Subject: Service Bulletin S14XP National Driver's Seat Shock Lower Mounting Tab Inspection

Models Affected: 2010-2013 Model Year All American and Vision Models

Blue Bird Shock Tab Inspection

Without Plate – Inspection Required

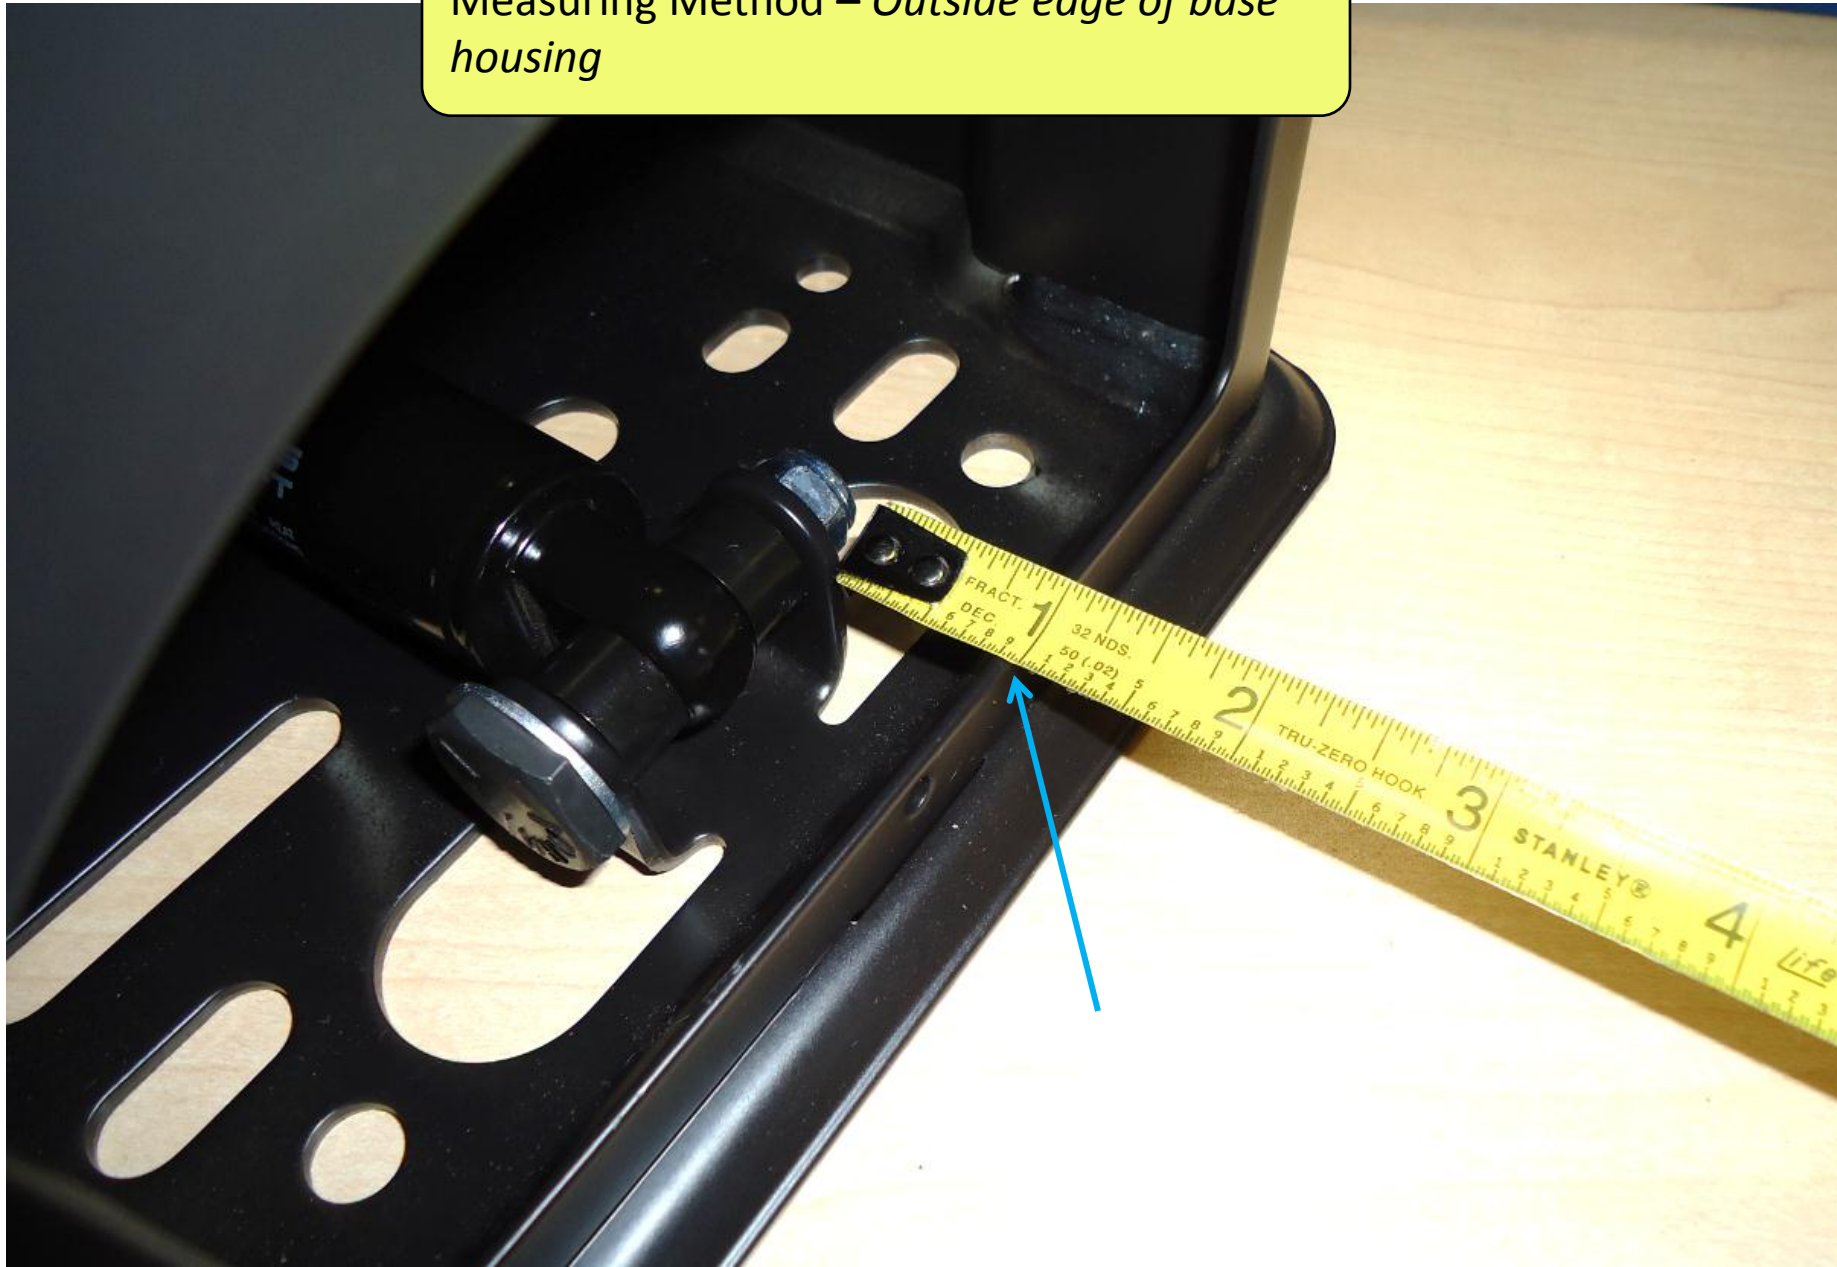
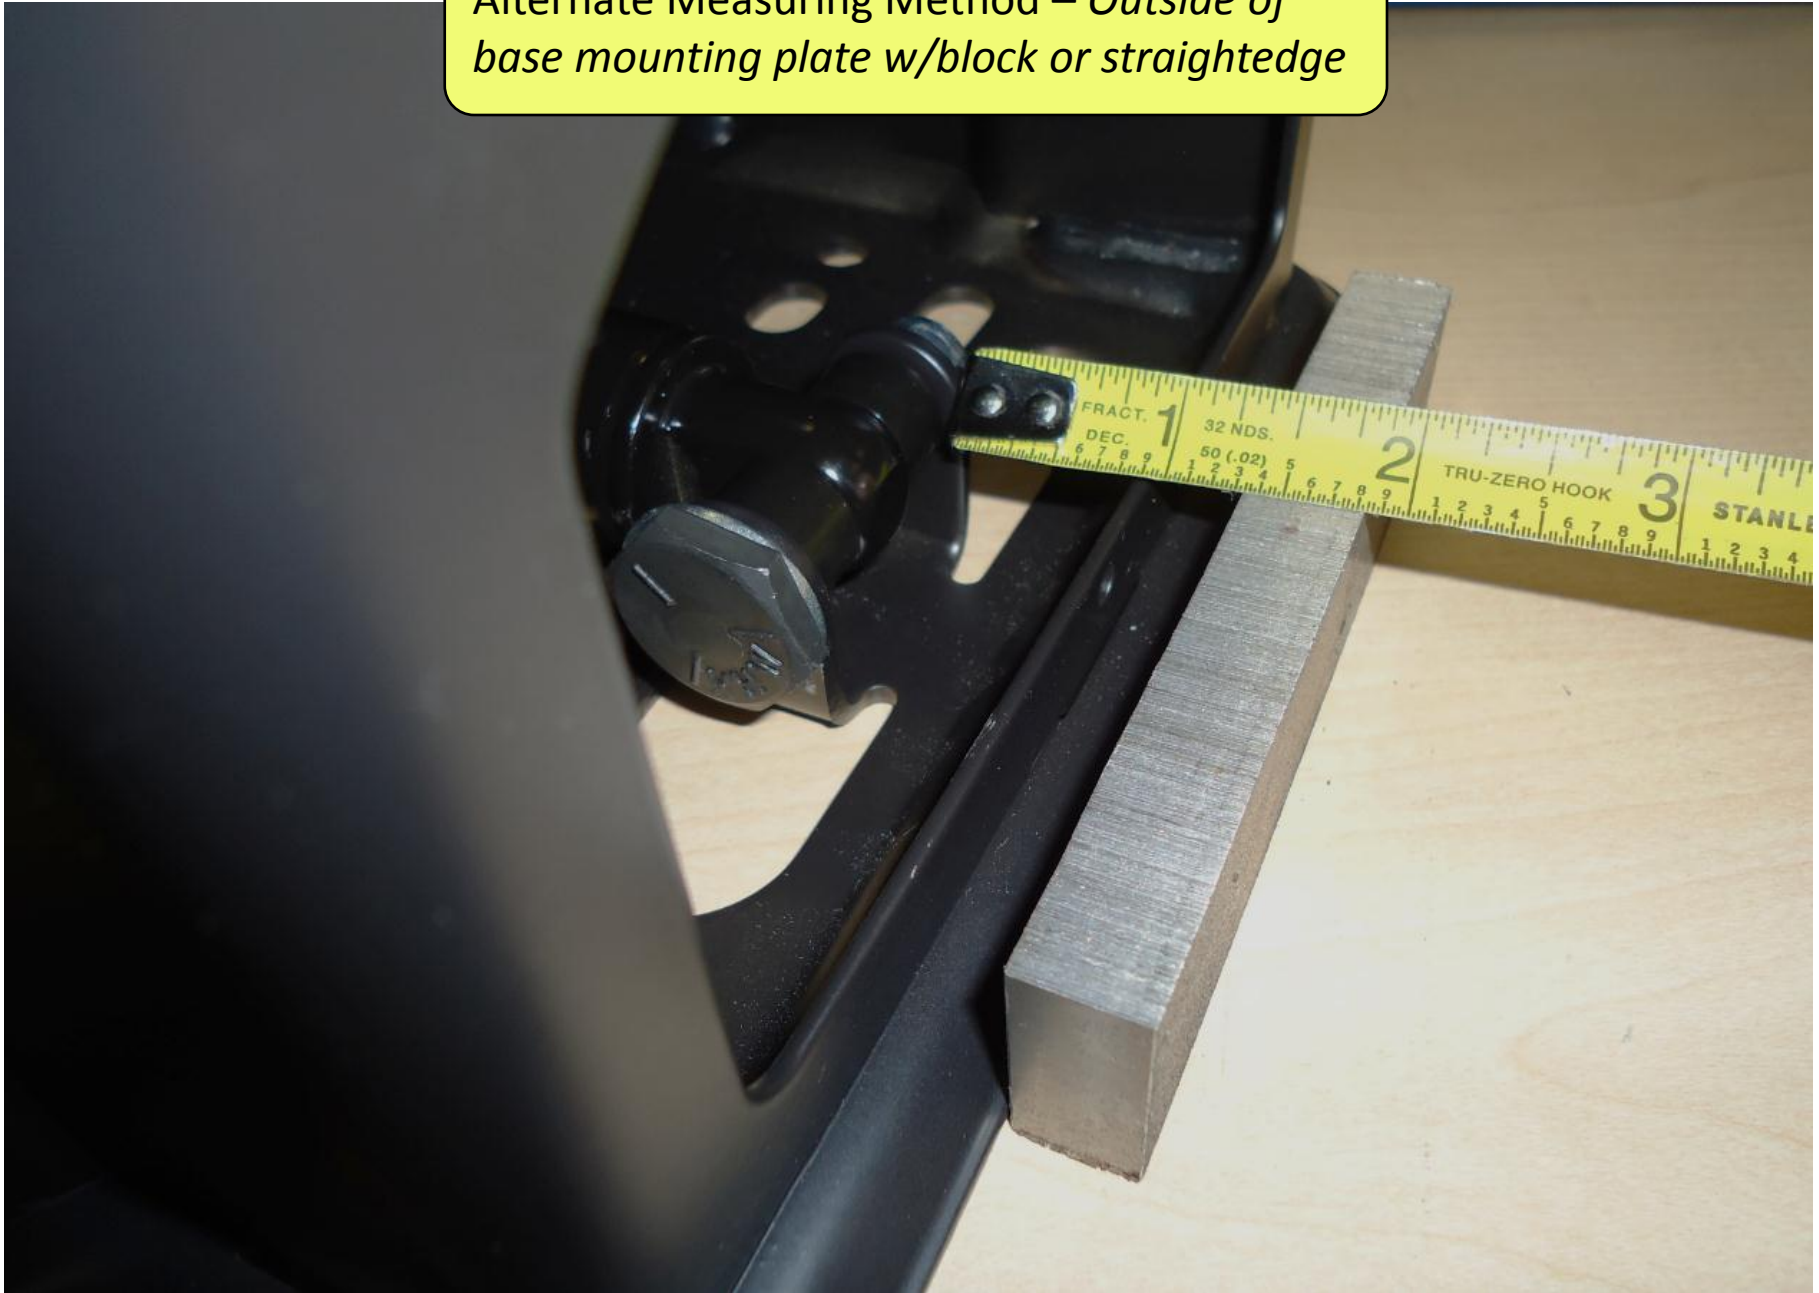
Measuring Method – *Outside edge of base housing*

Alternate Measuring Method – *Outside of base mounting plate w/block or straightedge*

-Original Specification-

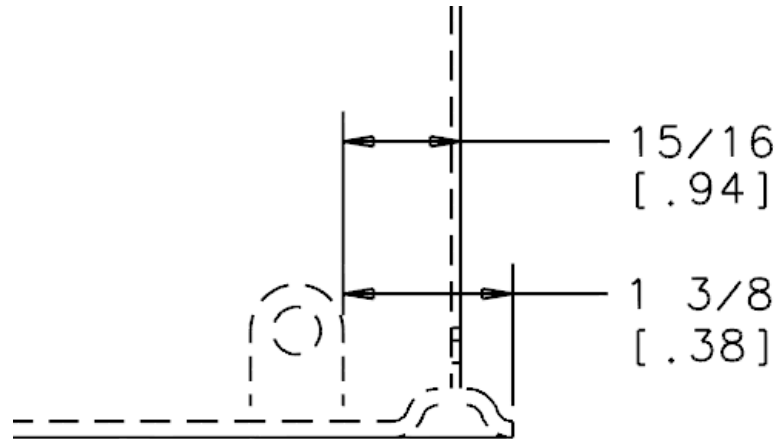
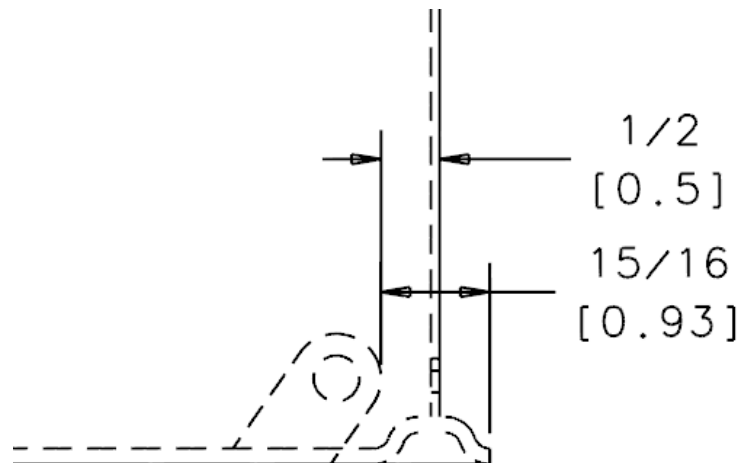
-Maximum Deformation -
(Service Kit required if measurement is less than this dimension)

INSTRUCTIONS

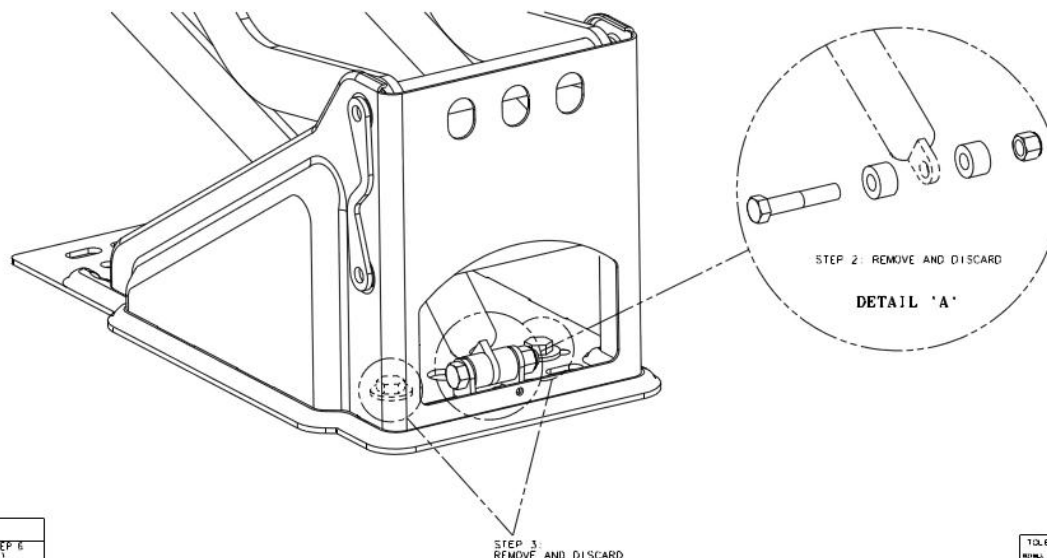
B	ADDED ITEM 7, ITEM 4 QUANTITY WAS 4 {14-1406, 9-4-16, JJ}
A	REMOVED ITEM 6, ITEM 4 QUANTITY WAS 2, STEP 6 TORQUE WAS 20FT LBS {14-1200, 4-28-14, JJ}
*	RELEASE {14-1166, 4-3-14, JJ}
SYM	CHANGE {E C N - DATE - BY}

- STEP 1: COLLAPSE BASE/SEAT TO FULL DOWN POSITION
- STEP 2: REMOVE AND DISCARD LOWER MOUNTING BOLTS, NUTS AND SPACERS (DETAIL 'A')
- STEP 3: REMOVE AND DISCARD THE FRONT MOUNTING BOLTS AND WASHERS
- STEP 4: PROCEED TO SHEET 2
